No:	SB145-13	Issue:	1
Date:	27/08/13	Sheet:	Page 1 of 1

SUBJECT: Steering U/J Pinch Bolt

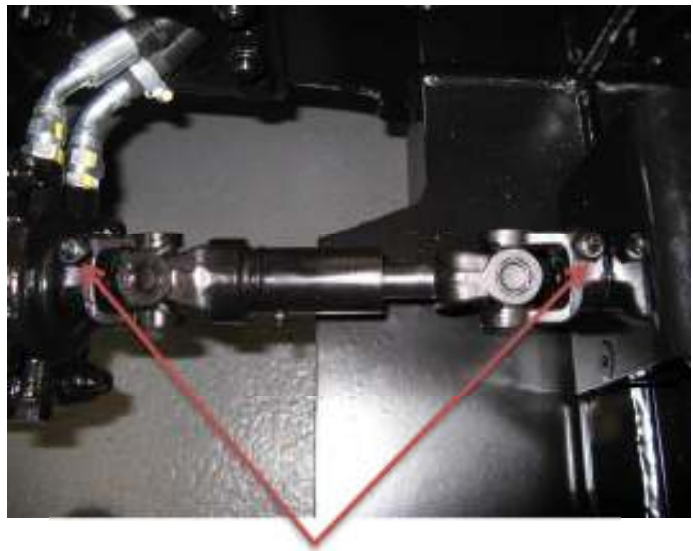
If during the life of a Dennis Elite the steering column U/J, bevel box, steering box or inter shaft require changing, you must ensure that the U/J pinch bolt is changed at the same time.

The replacement nut and bolt must be of a 10.9 grade, and torqued to 50Nm. This torque should then be checked during the routine six weekly maintenance checks.

Steering column U/J pinch bolts

Steering box to bevel box inter shaft U/J pinch bolts

Failure to change, torque and recheck the fixings could affect the steering performance of the vehicle.
